Do to the changes in design at the shoreline, we respectfully request the US Army Corps of Engineers to consider the amendment of Blocks 20 to 23 of the Application for the Department of the Army Permit, in order to correct the administrative process for the project of reference. The change promotes an administrative process under Section 404 of the Clean Water Act as well as under Section 10 of the Rivers and Harbor Act. The estimate of sandy material to be dredged in the first 10 meters from the mean high tide into the water is approximately 40 m<sup>3</sup>. This sandy material will be deposited for few hours in the dry beach area close to the shoreline, to be re-deposited or placed back to bury the cable from the mean high tide line along 10meters into the shallow waters (see diagram indicating temporary area for dredged sand and also for the trench sand).

Modification of Figure 6a of previous letter showing shoreline submarine cable installation design at the Condado Site.

Diagrams showing cross sections at point A, point B and point C along the cable burial line at the Condado Site.

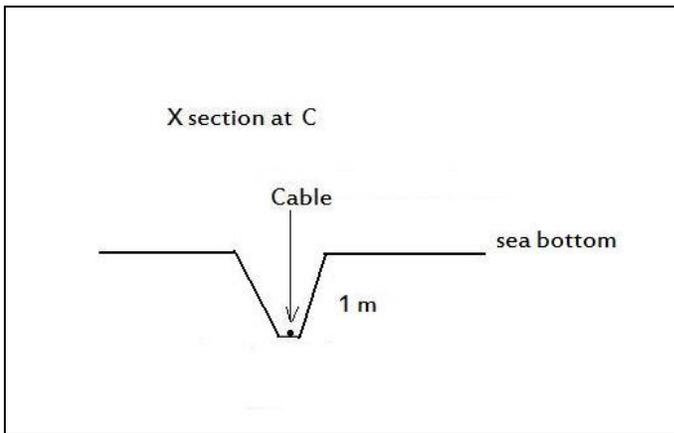
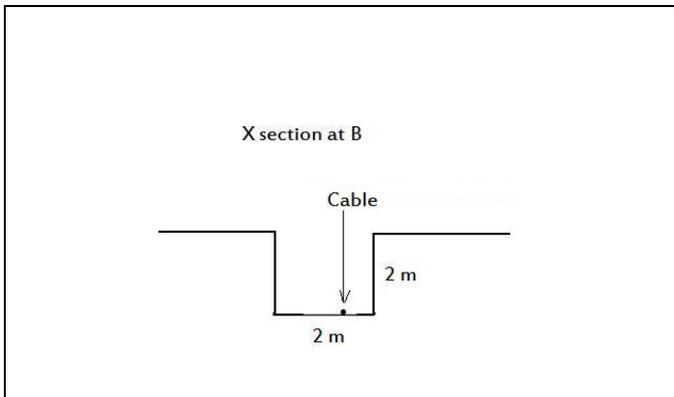
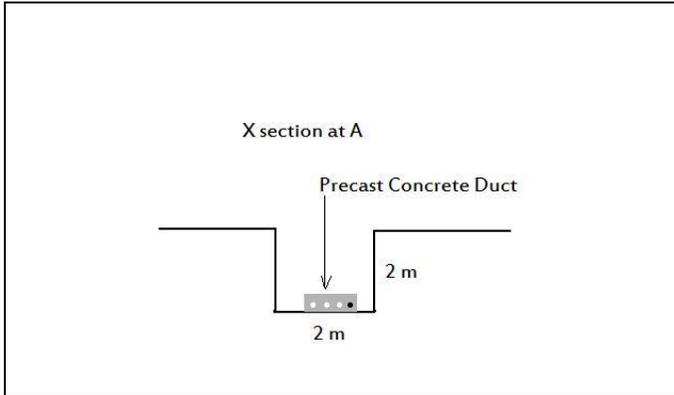
will go 2 meters deep in dry sand on the beach, but as the trench gets to the waterline, the sand will be saturated with water and will lose cohesiveness. The excavator may work in 0.5 m of water (subject to wave height) and do burial attempts as far out as bucket can reach from this position after which cable is fully exposed on seabed all the way out. At 5 meters from the mean high tide, the cable will be buried at approximately one meter deep on the seabed. At 10 meters the cable should be starting to get exposed.
